1	INC. DCN 15102-029C-3 PER DCR 99-0042 AND DCN 15102-029C-4 PER DCR 00-1766	SDW			
2	INC. DCN 15102-029C-2 PER DCR 97-1047		INITIALS ON FILE		
3	INC. DCN 15102-029C-1 FOR DCR 91-0011		INITIALS ON FILE		
4	ISSUED FOR SECOND 10 YEAR ISI PROGRAM		LPM	TWS	MGP ECC
REV.	DATE	REVISION	BY	CHKD.	APPD.
SCALE N.T.S.	DESIGNED	DRWN	CB	DATE	
DAVIS-BESSE NUCLEAR POWER STATION					
UNIT NO. 1					
THE TOLSON DESIGN COMPANY					
INSERVICE INSPECTION DIAGRAM					
CONTAINMENT AND PENETRATION ROOMS					
SHEET 2					
DRWING NO.	REV.				
15102-029C	3

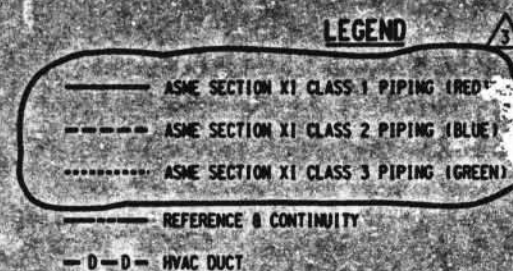
INFO. NOTE:
(REMOVE AT NEXT UPDATE)
REVISION CHANGE IN THE CLOUDED
AREA WAS FOR COLORIZING THE
LINE CLASS CODES (REF. DCN 4)

INFO. NOTE:
(REMOVE AT NEXT UPDATE)
REVISION CHANGE IN THE CLOUDED
AREA WAS FOR COLORIZING THE
LINE CLASS CODES (REF. DCN 4)

INFO. NOTE:
(REMOVE AT NEXT UPDATE)
REVISION CHANGE IN THE CLOUDED
AREA WAS FOR COLORIZING THE
LINE CLASS CODES (REF. DCN 4)

INFO. NOTE:
(REMOVE AT NEXT UPDATE)
REVISION CHANGE IN THE CLOUDED
AREA WAS FOR COLORIZING THE
LINE CLASS CODES (REF. DCN 4)
